Village "A"

Adopted November 28, 2005 (DCP-05-03)
Adopted as Amended July 27, 2009 (VBA-90-93)
Adopted as Amended October 24, 2014 (VPA-14-010)

Village District Site Analysis, Preliminary VDPP, & Final VDPP *Amendment for Neighborhood No. 8*

Prepared by:
Matthew P. Block, AICP, ICMA CM
November 2016

Figure 1.2.A Neighborhoods Plan

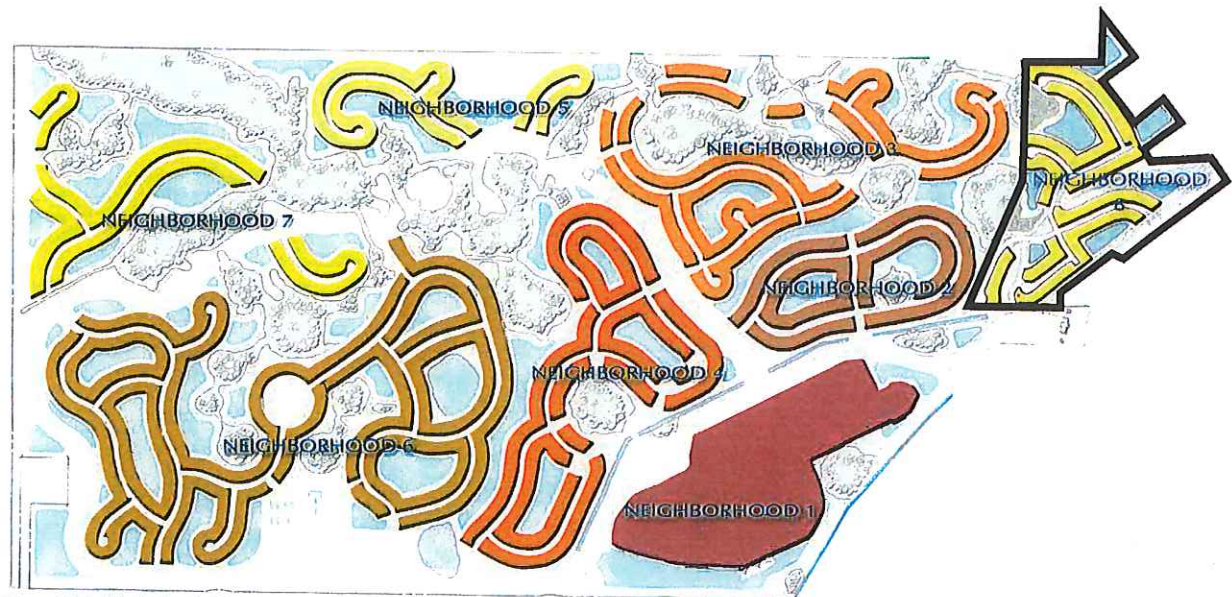
1. Updated Figure 1.2.A
2. Updated paragraphs 1 and 2

Figure 1.3.A Neighborhood Centers Plan

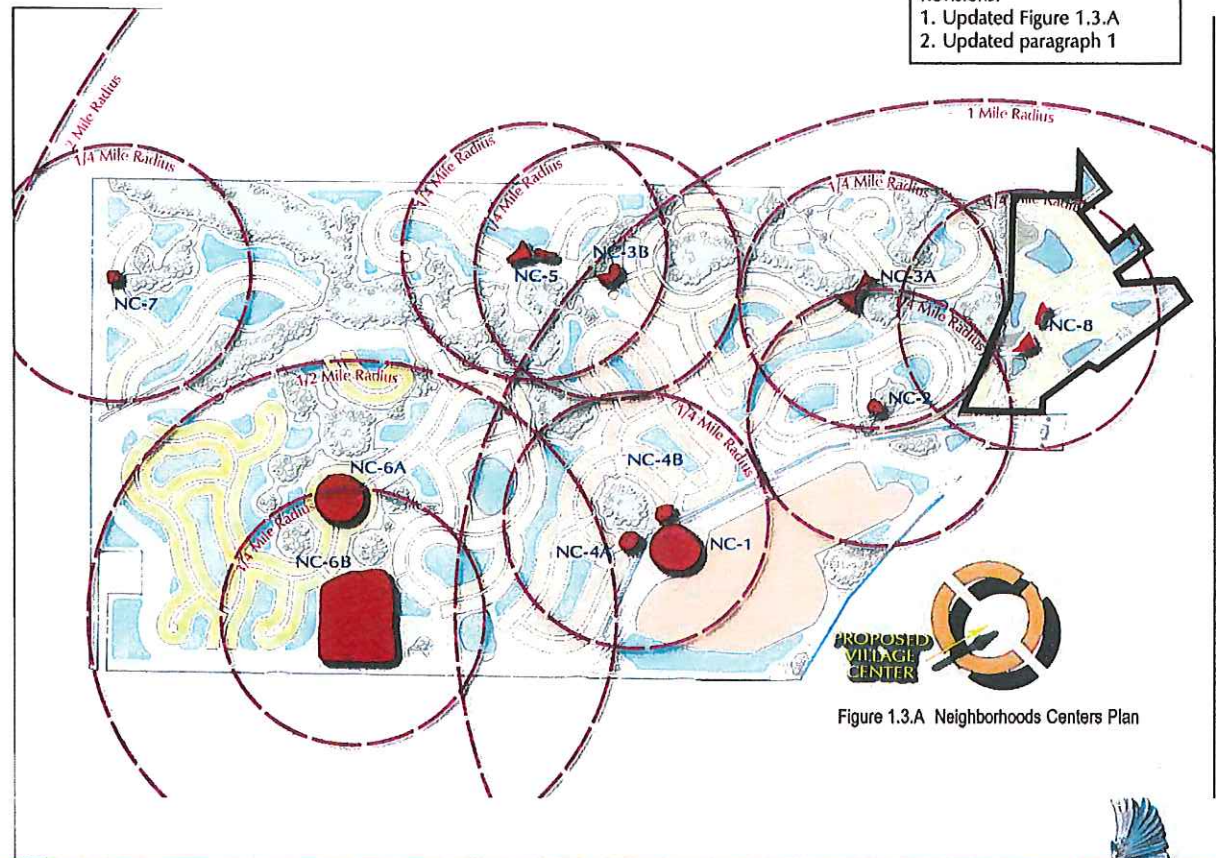
1. Updated Figure 1.3.A
2. Updated paragraph 1

Figure 3.1.B Single-Family Detached Structure Types and Standards for Neighborhoods 1-7

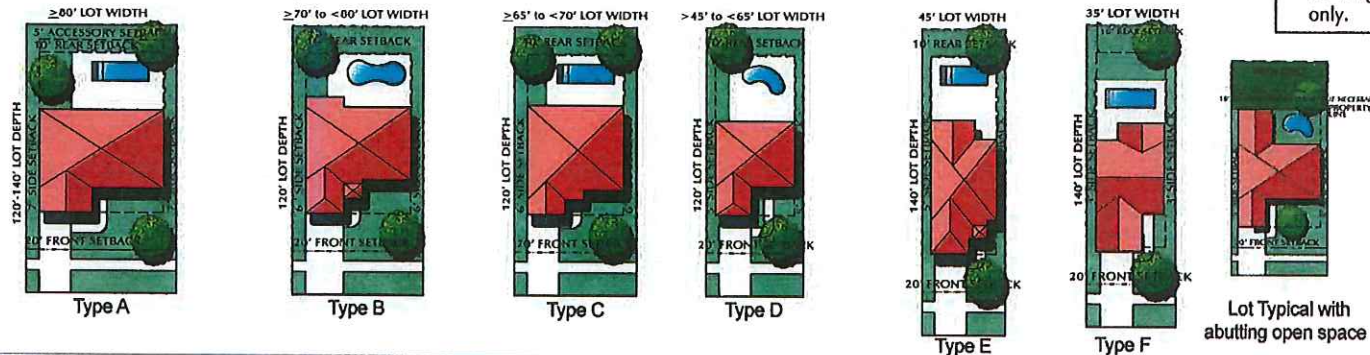
Revisions:
1. Updated subtitle to clarify for Neighborhoods 1-7 only.

Figure 3.1.C Single-Family Detached Structure Types and Standards for Neighborhood 8

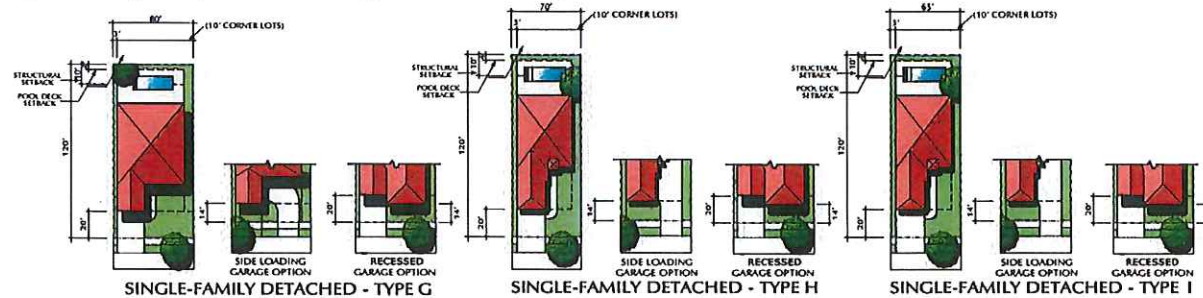
Revisions:
1. Updated subtitle to clarify for Neighborhood 8 only.

Figure 4.1.A Roadways Plan

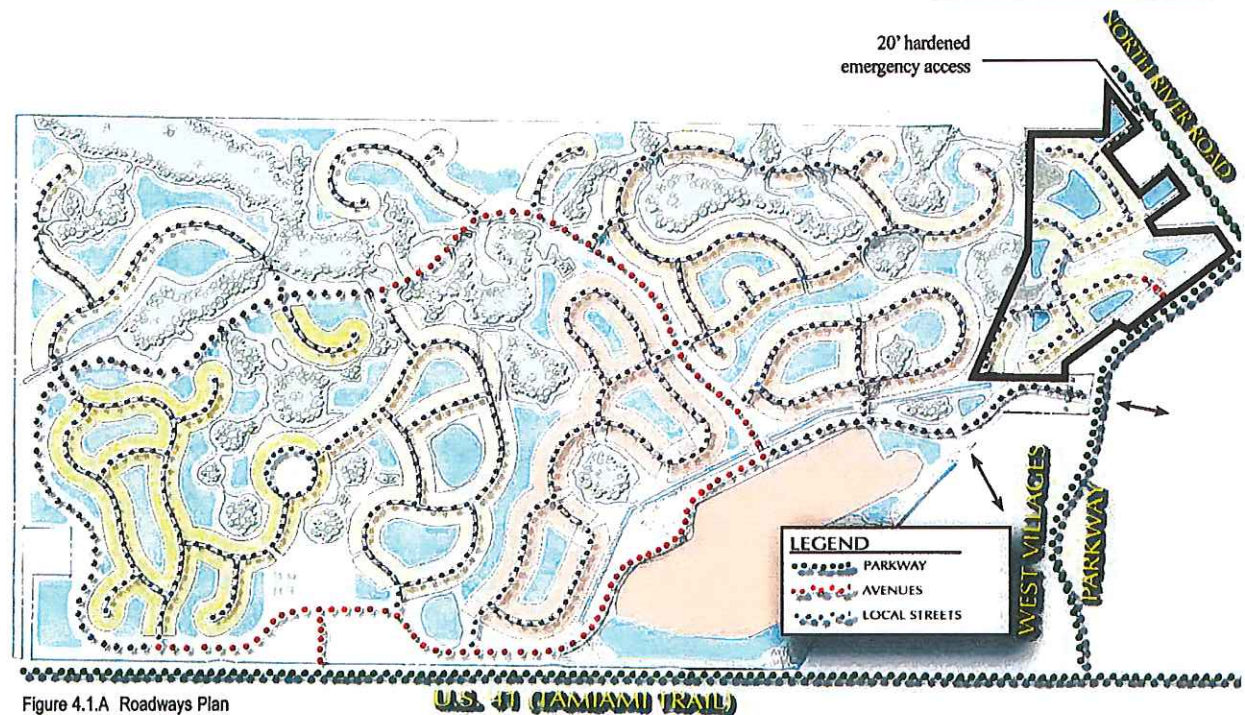
1. Updated Figure 4.1.A

Figure 4.2.A Proposed Pathway Plan

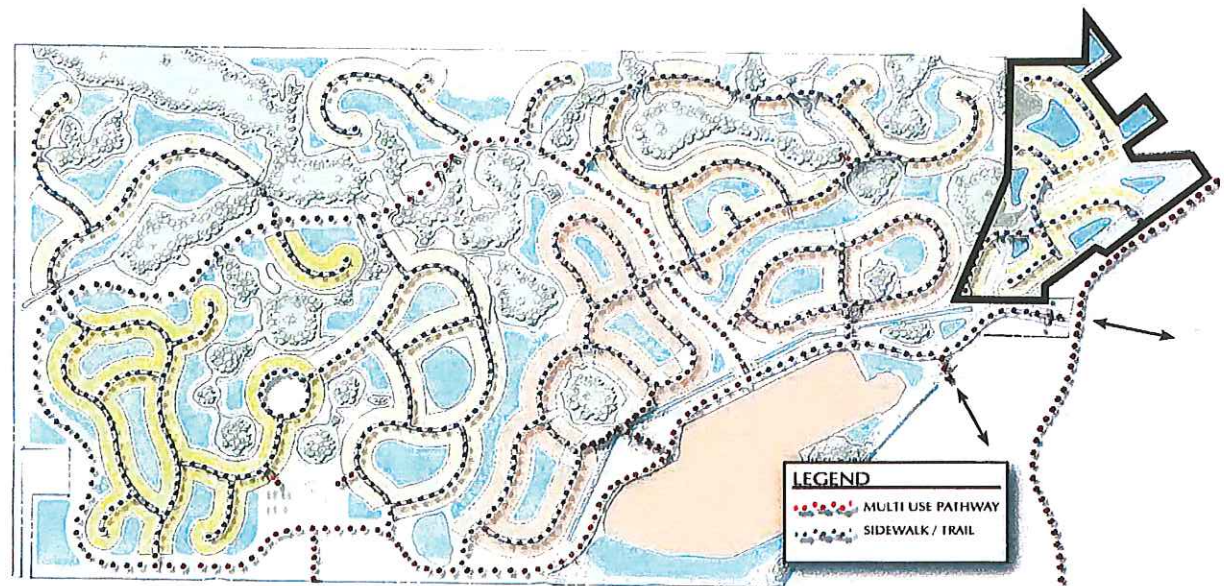
Revisions:
1. Updated Figure 4.2.A

Figure 5.2.A Water System Plan

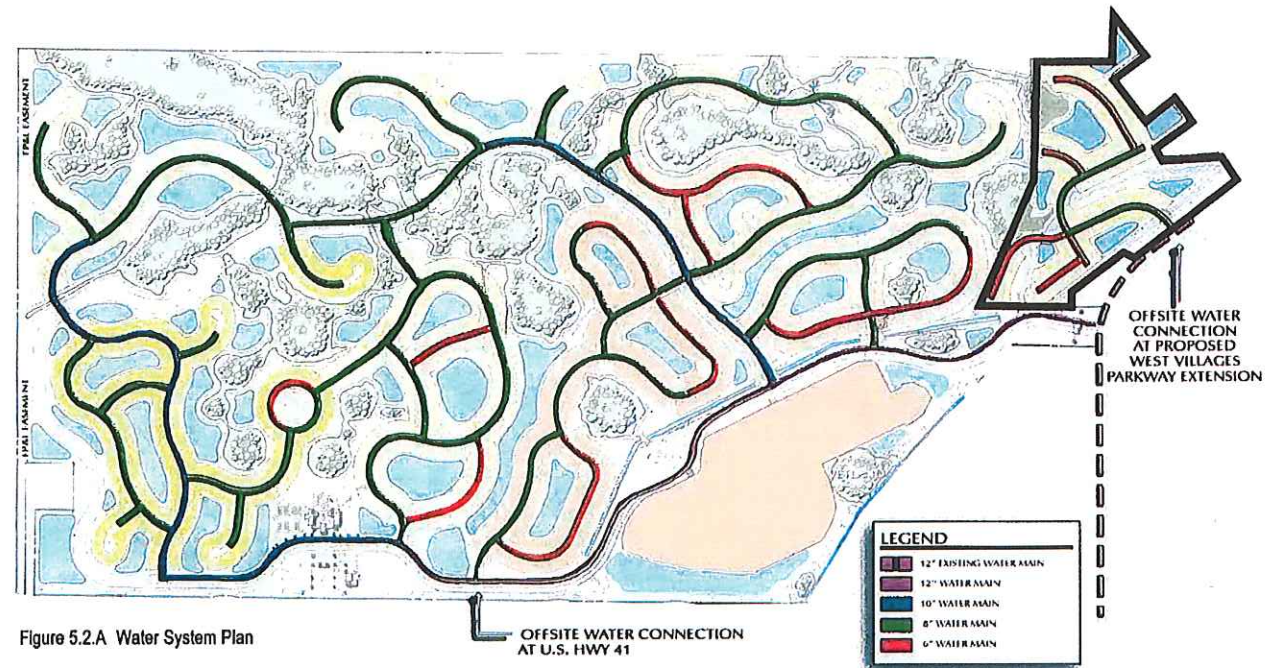
1. Updated Figure 5.2.A
2. Updated Paragraphs 2 and 3

Figure 5.3.A Wastewater System Plan

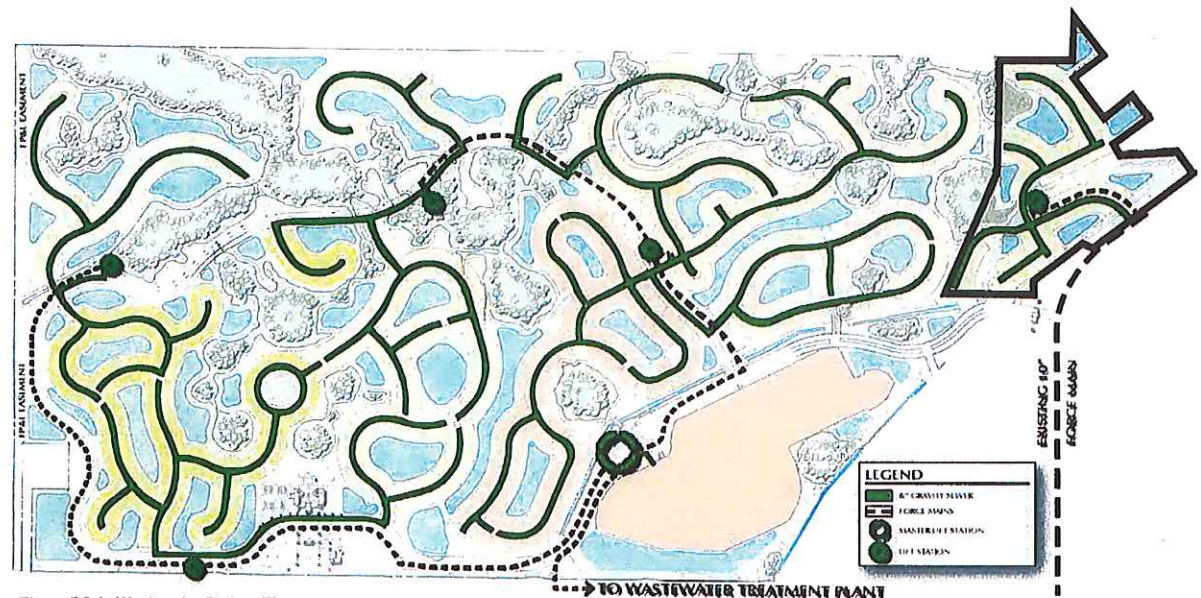
1. Updated Figure 5.3.A
2. Updated Paragraphs 1, 2 and 3

Figure 6.3.A Wetland Plan

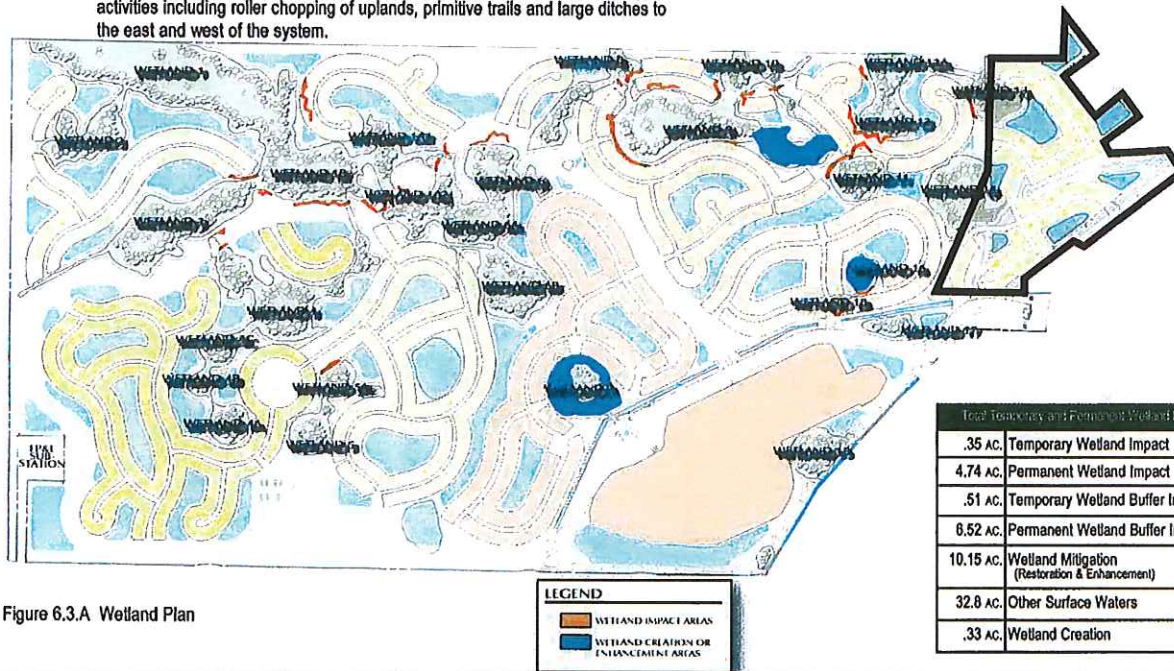
1. Updated Figure 6.3.A
